SUBJECT: PLANS AND PROPOSAL ADDENDUMS

PROJECT: CM 2023(611)

CONTROL: 0092-02-137

PROPOSAL ADDENDUMS

IH45 ITS UPGRADE LAYOUT

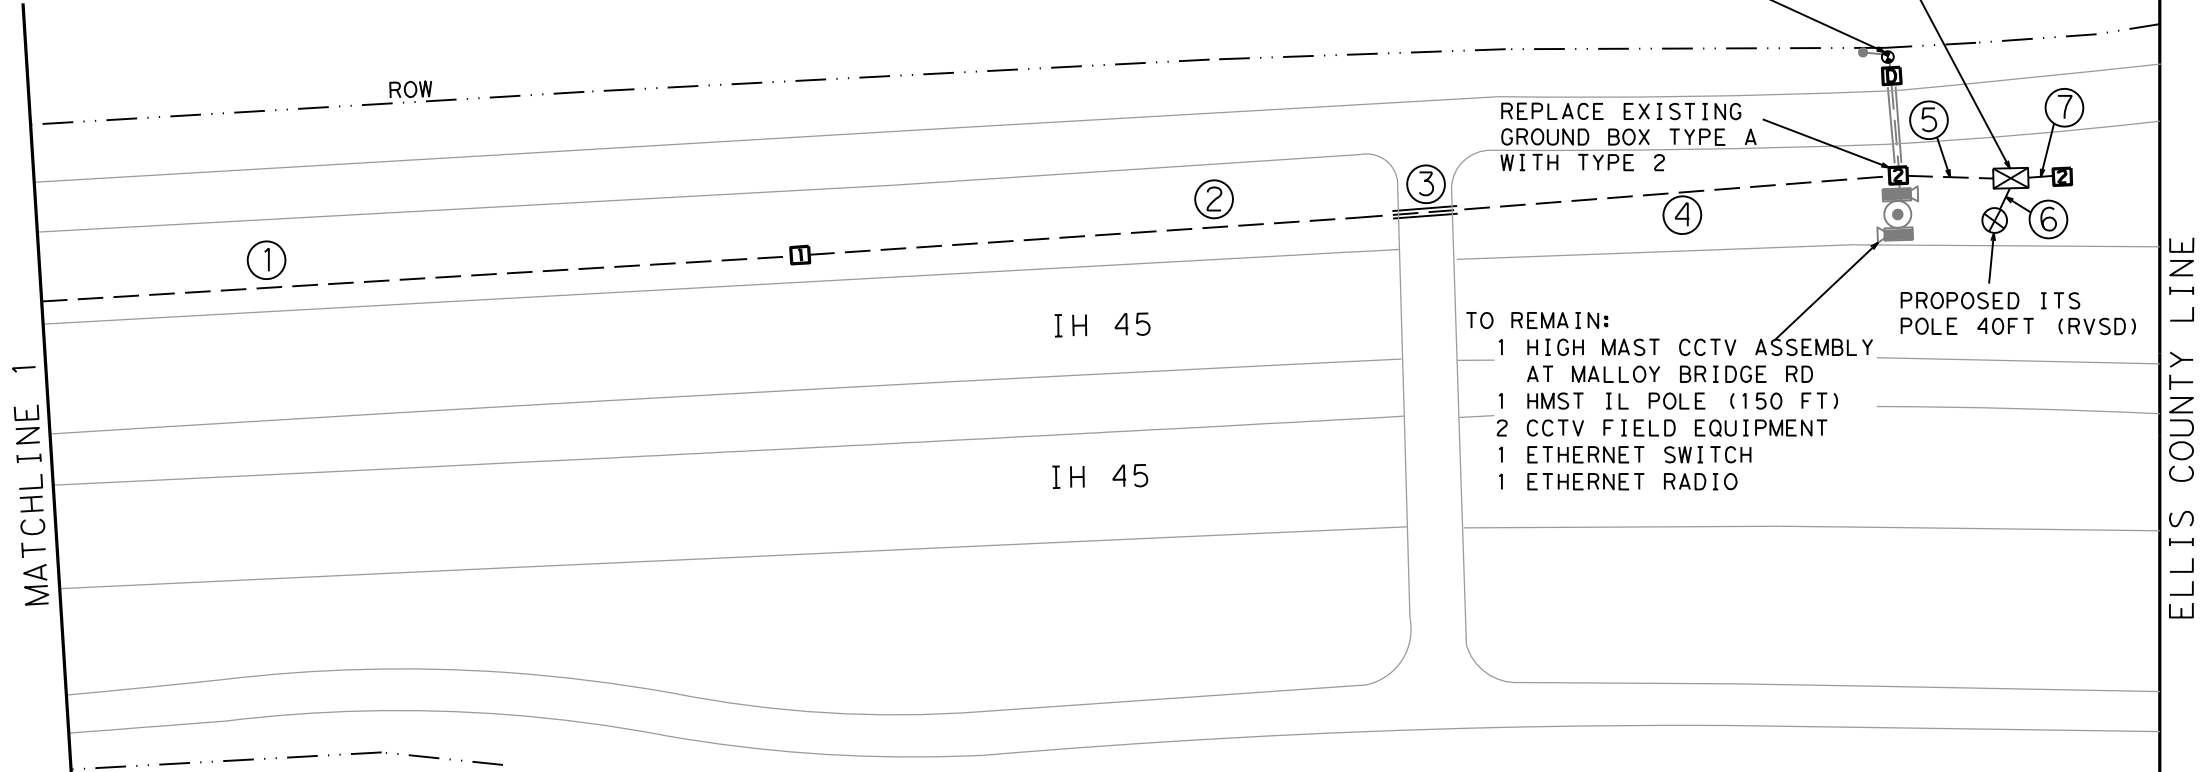
*****bid inserts*****
adjusted quantities for the following bid items:628-6151,6062-6042
added following missing bid items:624-6028,628-6002,6064-6019
*****plans sheets*****
Sheet 4,4a,5,5a,5b: updated bid items and quantities
Sheet 6a: updated sheet
Sheet 7: updated bid items 628-6002,628-6151,624-6028,6062-6042,6064-6019
Sheet 12: added bid item 628-6151
Sheet 17: added bid item 628-6151
Sheet 22: updated bid items 624-6028,628-6002,628-6151,6062-6042,6064-6019
Sheet 38: updated bid items 624-6028,628-6002,628-6151,6062-6042,6064-6019
Sheet 50: added bid item 6062-6042

REPLACE EXISTING ELEC SERV TY T (120/240)000(NS)GS(N)TP(O)
 WITH ELEC SERV #01 TY D (120/240)060(NS)SS(N)PS(U)

REPLACE EXISTING GROUND BOX TYPE A WITH TYPE 2

- ETHERNET RADIO POINTED SOUTH NEEDS TO STAY IN PLACE FOR EXISTING NETWORK COMMUNICATION.
- ETHERNET RADIO POINTED NORTH TO BELT LINE RD TO POINT DOWN TO PROPOSED RVSD POLE. THIS WORK WILL BE SUBSIDIARY TO ITEM 6062.
- INSTALL ETHERNET RADIO REMOVAL FROM IH 20 - IH45 HIGH MAST THAT WAS POINTED SOUTH AND INSTALL ON PROPOSED RVSD POLE TO POINT UP TO MALLOY BRIDGE HIGH MAST.
- THE CONTRACTOR SHALL ENSURE THAT THE EXISTING DALLAS DISTRICT ITS SYSTEM REMAINS OPERATIONAL THROUGHOUT THE INSTALLATION OF THE PROPOSED ELECTRICAL SERVICE WITH A MAXIMUM LAPSE OF 24 HOURS PER OUTAGE.

IH45 ITS UPGRADE LAYOUT

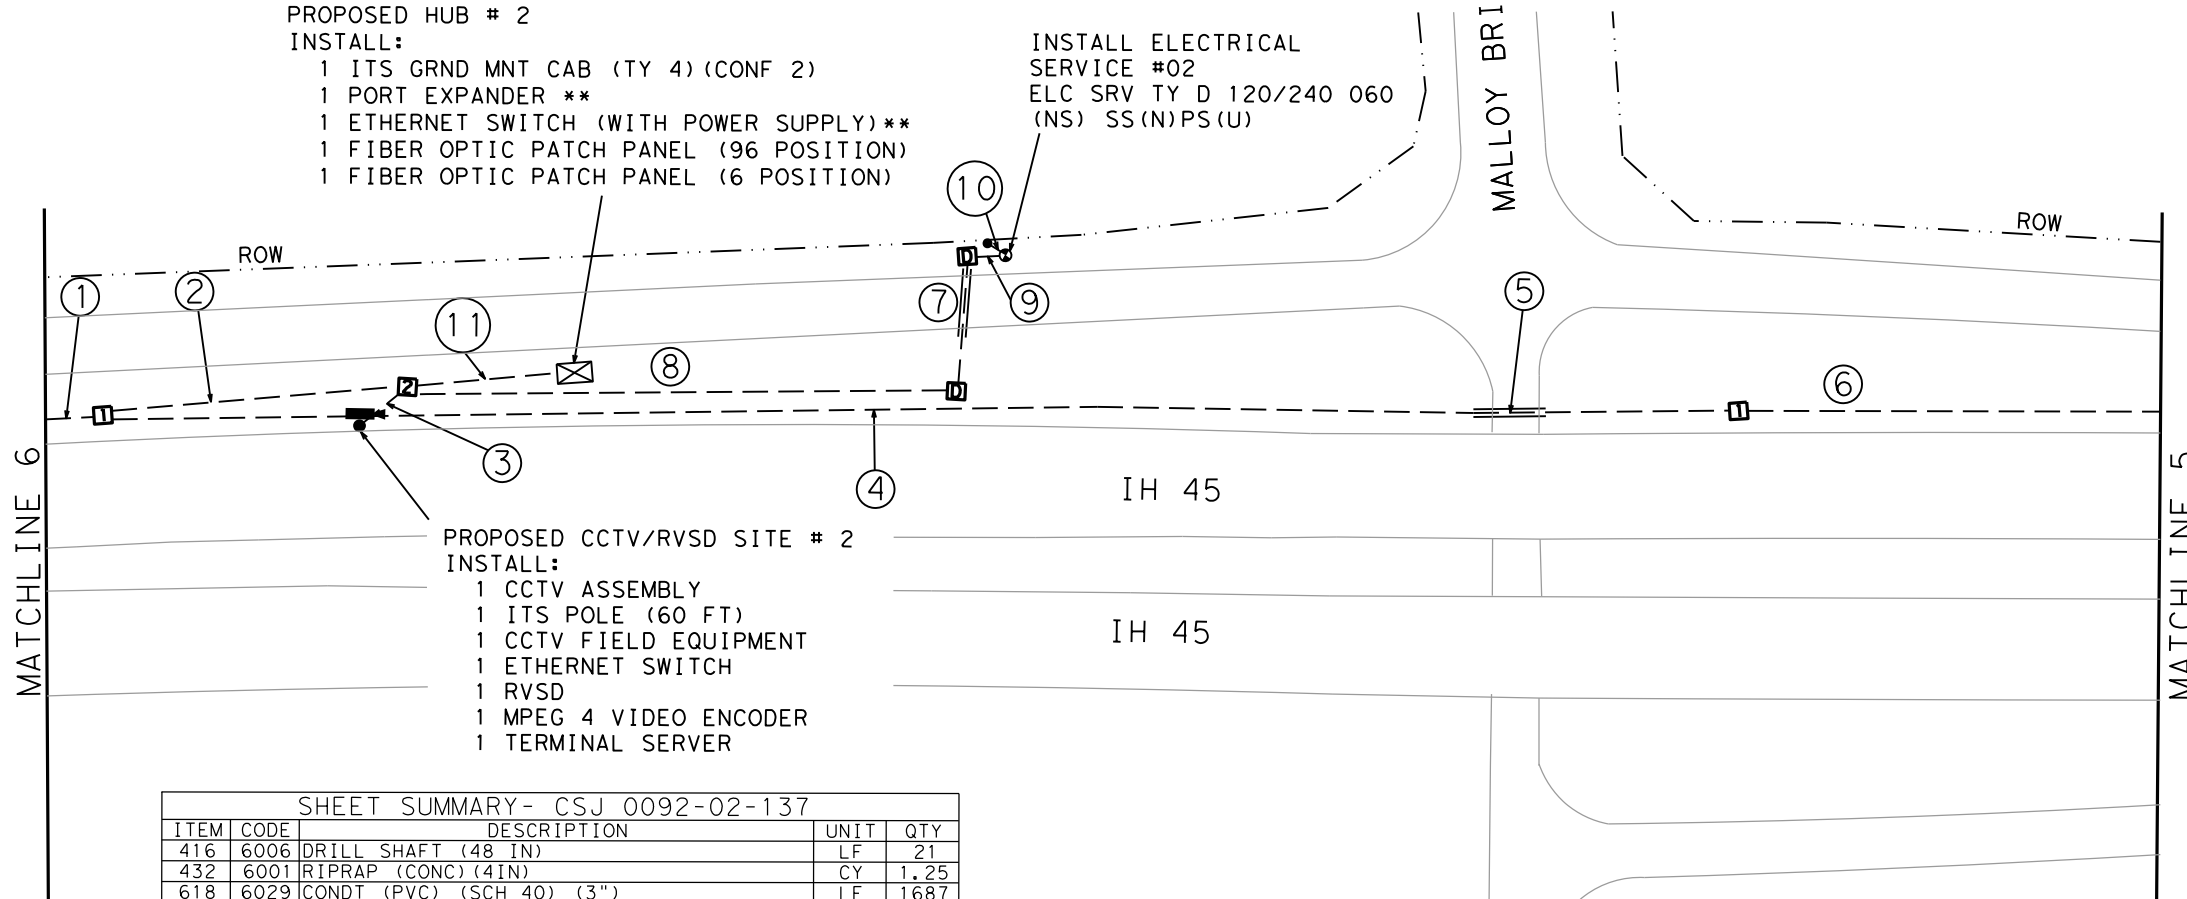
INSTALL ELECTRICAL SERVICE #02
ELC SRV TY D 120/240 060 (NS) SS(N)PS(U)

IH45 ITS UPGRADE LAYOUT

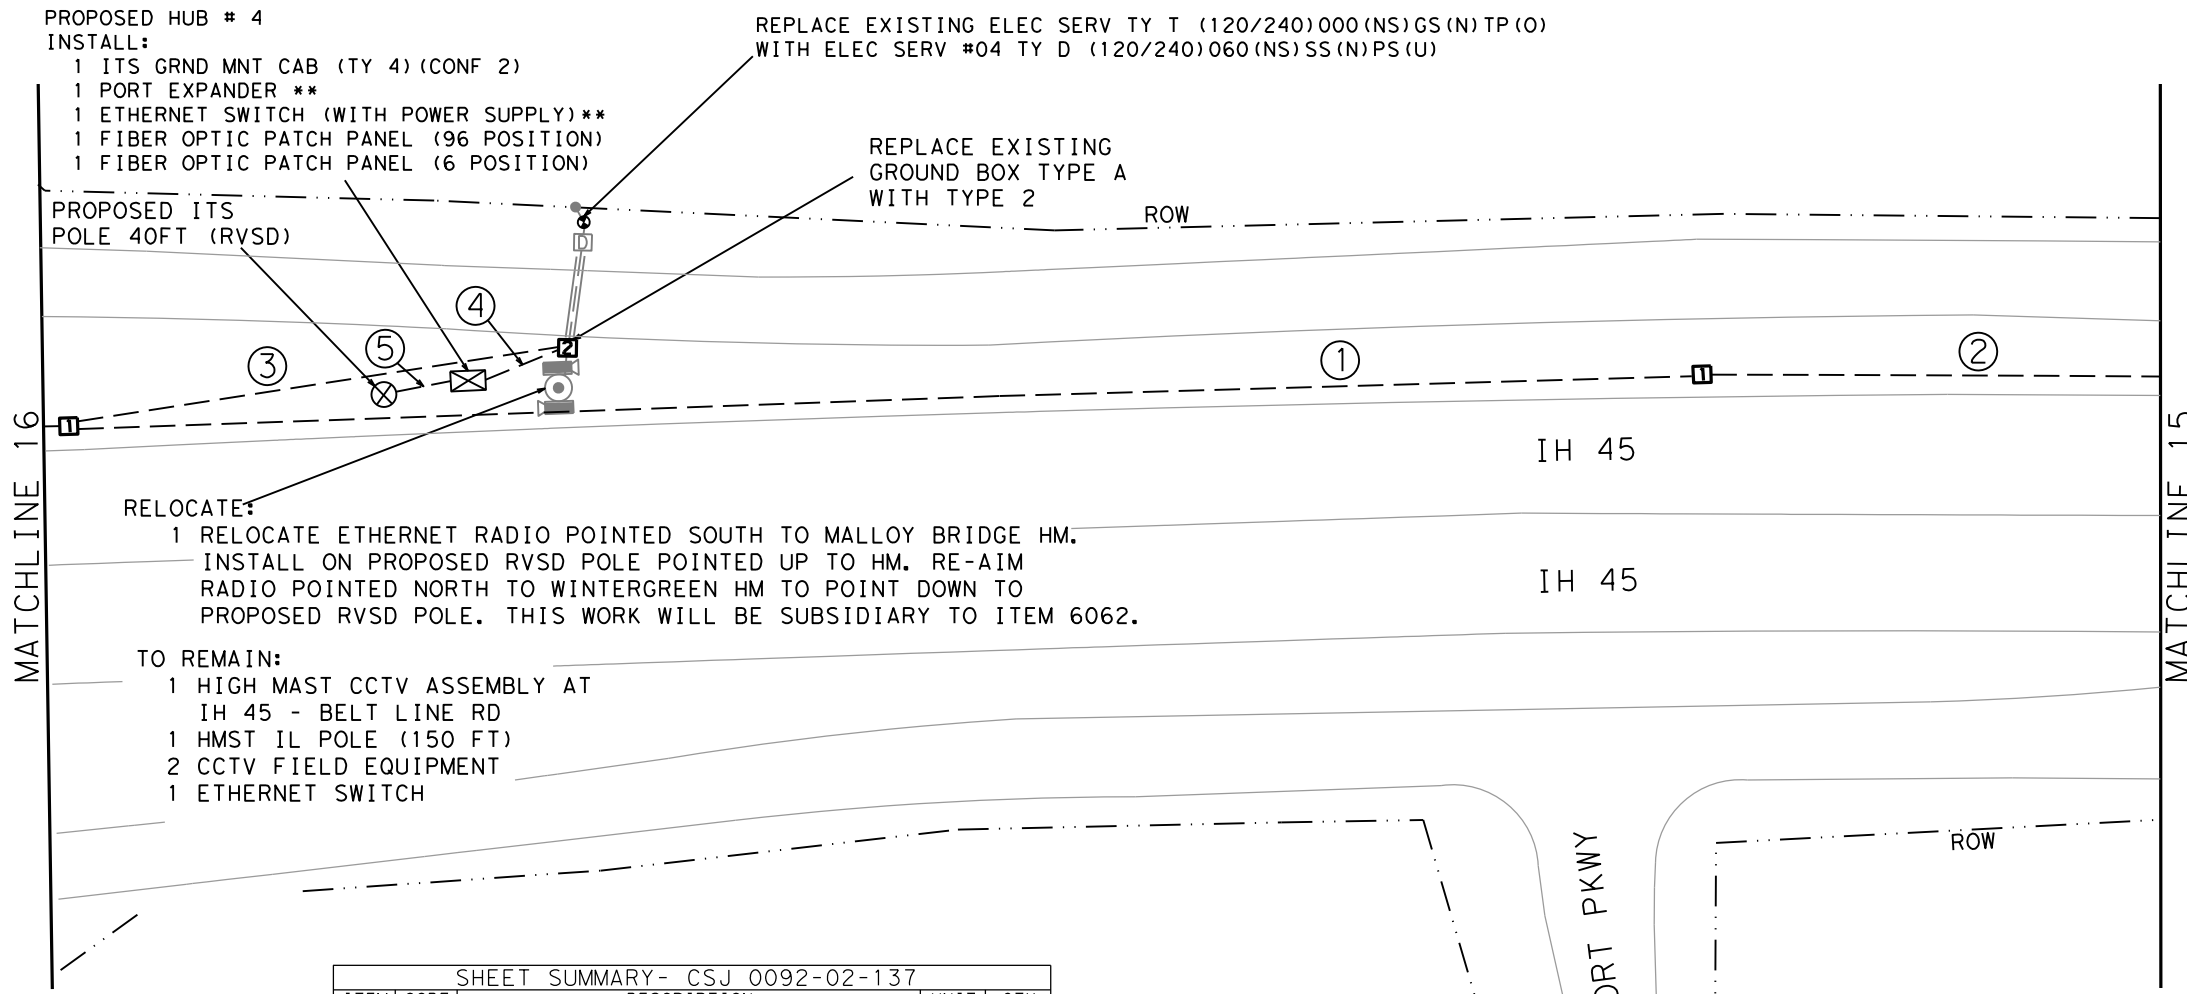
- PROPOSED HUB # 4**
INSTALL:
 1 ITS GRND MNT CAB (TY 4) (CONF 2)
 1 PORT EXPANDER **
 1 ETHERNET SWITCH (WITH POWER SUPPLY)**
 1 FIBER OPTIC PATCH PANEL (96 POSITION)
 1 FIBER OPTIC PATCH PANEL (6 POSITION)
- RELOCATE:**
 1 RELOCATE ETHERNET RADIO POINTED SOUTH TO MALLOY BRIDGE HM.
 INSTALL ON PROPOSED RVSD POLE POINTED UP TO HM. RE-AIM
 RADIO POINTED NORTH TO WINTERGREEN HM TO POINT DOWN TO
 PROPOSED RVSD POLE. THIS WORK WILL BE SUBSIDIARY TO ITEM 6062.
- TO REMAIN:**
 1 HIGH MAST CCTV ASSEMBLY AT
 IH 45 - BELT LINE RD
 1 HMST IL POLE (150 FT)
 2 CCTV FIELD EQUIPMENT
 1 ETHERNET SWITCH

IH45 ITS UPGRADE LAYOUT

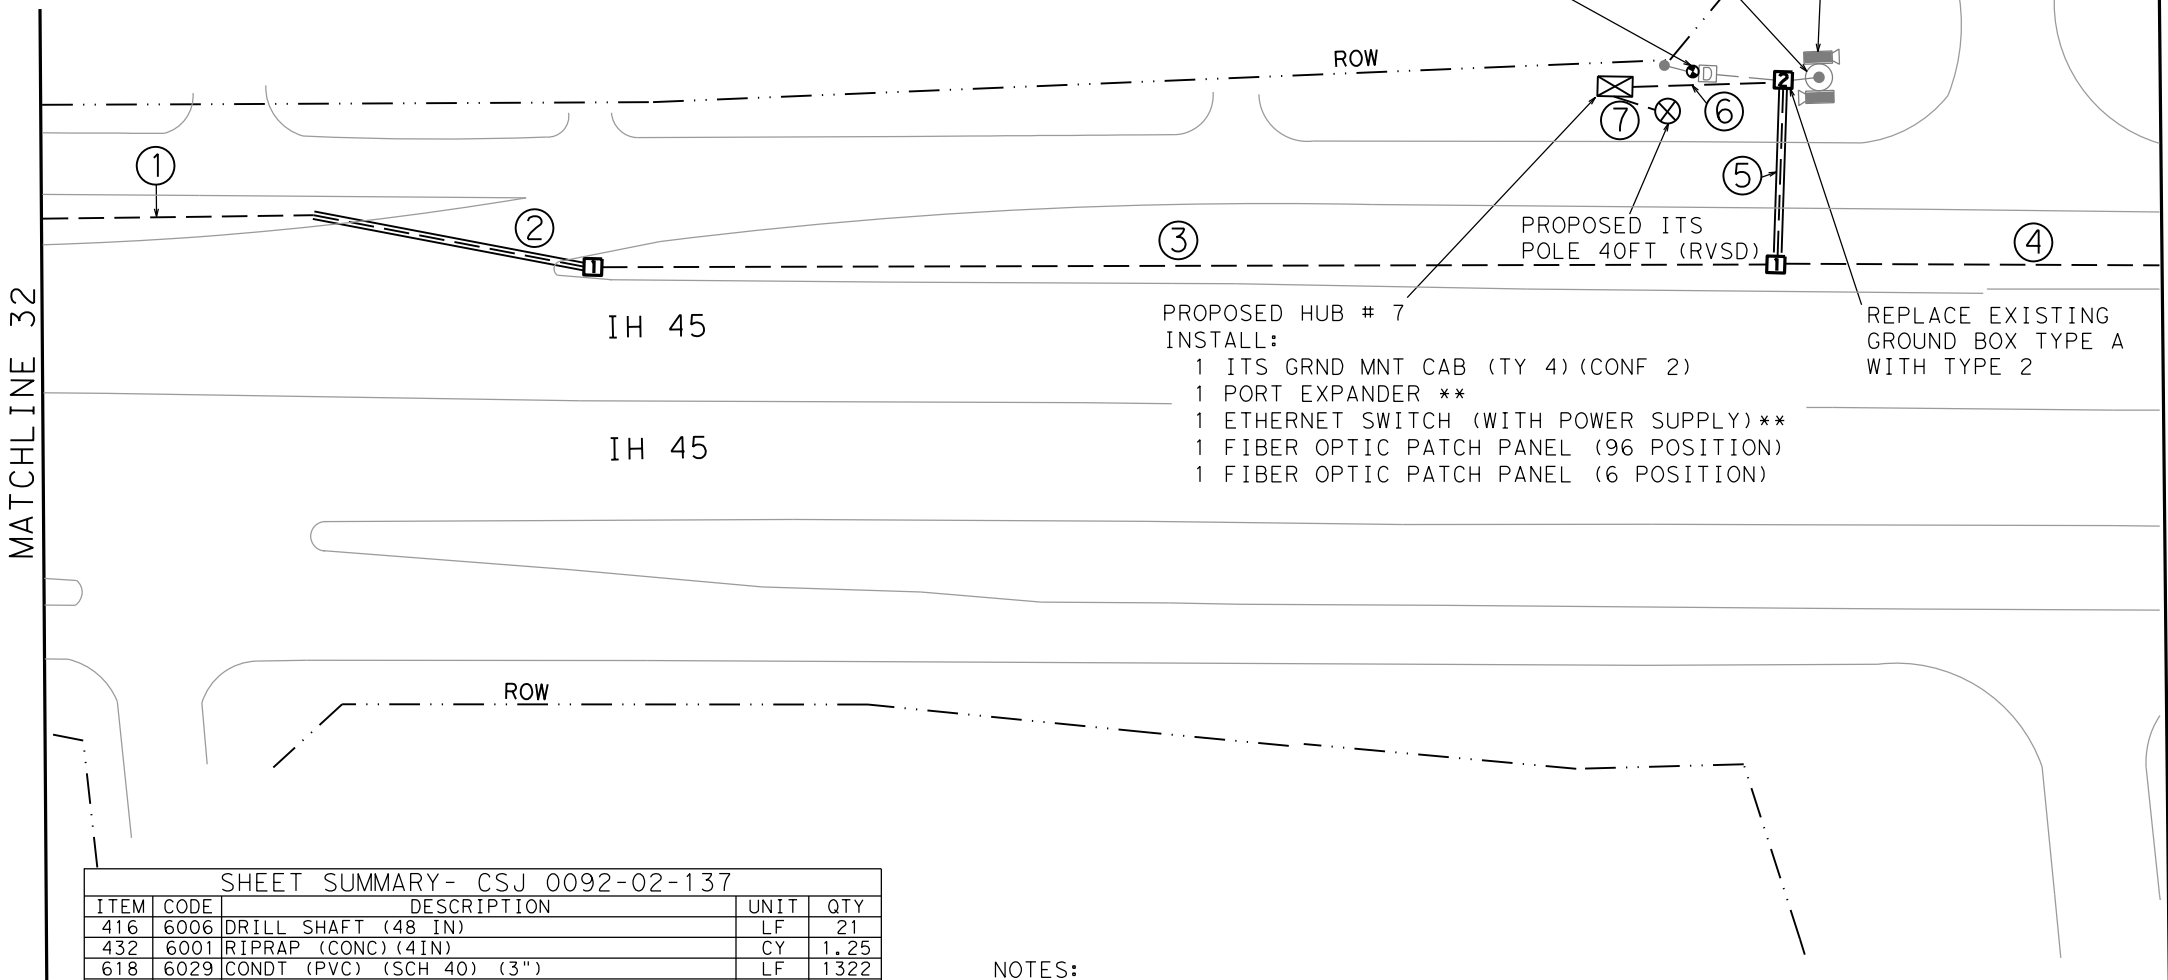
RELOCATE:
1 RELOCATE ETHERNET RADIO POINTED SOUTH TO BELT LINE HM. INSTALL ON RVSD POLE TO POINT UP TO HM. RE-AIM ETHERNET RADIO POINTED NORTH TO IH 20-IH45 HM TO POINT DOWN TO PROPOSED RVSD POLE. THIS WORK WILL BE SUBSIDIARY TO ITEM 6062.

REPLACE EXISTING ELEC SERV TY T (120/240)000(NS)GS(N)TP(O) WITH ELEC SERV #07 TY D (120/240)060(NS)SS(N)PS(U)
